SUBJECT: Responds to request for info re 871215 application for amend
to License NPF-21 re final feedwater temp reduction.

Subject: NUCLEAR PLANT NO. 2, OPERATING LICENSE NPF-21
REQUEST FOR AMENDMENT TO TECHNICAL SPECIFICATIONS,
FINAL FEEDWATER TEMPERATURE REDUCTION (FFTR)

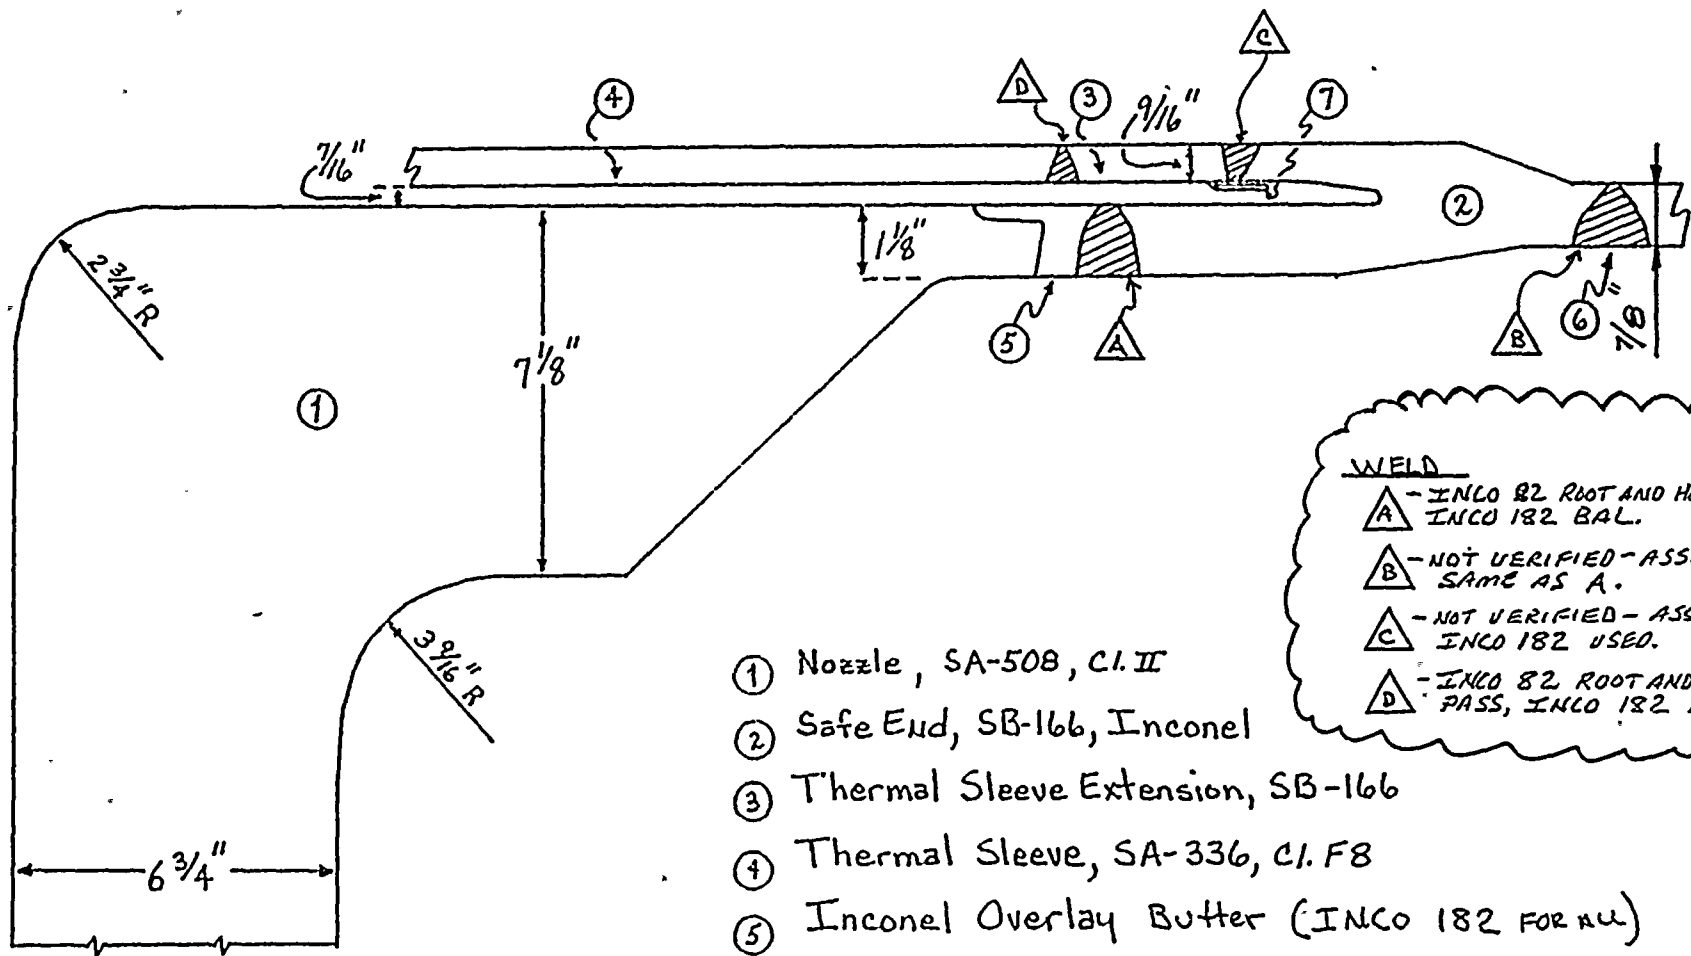
- 4) The Supply System was asked to confirm the type of weld filler material that was used in the four (4) welds shown in Figure 121.8-1 (i.e. Inconel-82 versus Inconel-182). We assume this is related to the GE SIL No. 455, Revision 1 dated February 22, 1988.

Two of the four welds (see attachment) have been confirmed as containing Inconel-182 material, and it is assumed the other two also contain the same material. The Supply System does not believe that resolution of the Staff's Inconel-182 concerns should be germane to the Staff's approval of the Supply System's request to operate at reduced feedwater temperature at EOC for the purpose of extending the cycle. The Inconel-182 weld metal concerns are not so sensitive to final temperature that FFTR (as compared to normal, anticipated operating conditions) in itself should be a concern. However, in the interest of resolution of this issue, the Supply System agrees to ultrasonically examine the bore and inner radius of one feedwater nozzle at the refueling outage following the use of FFTR for cycle extension (if one nozzle was already scheduled for examination, that would suffice). The examination will comply with the Augmented Feedwater Nozzle Examination Program the Supply System has previously committed to in the ISI Program Plan submitted to the NRC May 29, 1985.

- ① Nozzle, SA-508, C.I. II
- ② Safe End, SB-166, Inconel
- ③ Thermal Sleeve Extension, SB-166
- ④ Thermal Sleeve, SA-336, C.I. F8
- ⑤ Inconel Overlay Butter (INCO 182 FOR ALL)
- ⑥ Weld Illustration
- ⑦ Back-up Ring, SB-168

- △ - INCO 82 ROOT AND HOT PASS, INCO 182 BAL.
- △ - NOT VERIFIED - ASSUME SAME AS A.
- △ - NOT VERIFIED - ASSUME INCO 182 USED.
- △ - INCO 82 ROOT AND HOT PASS, INCO 182 BAL.
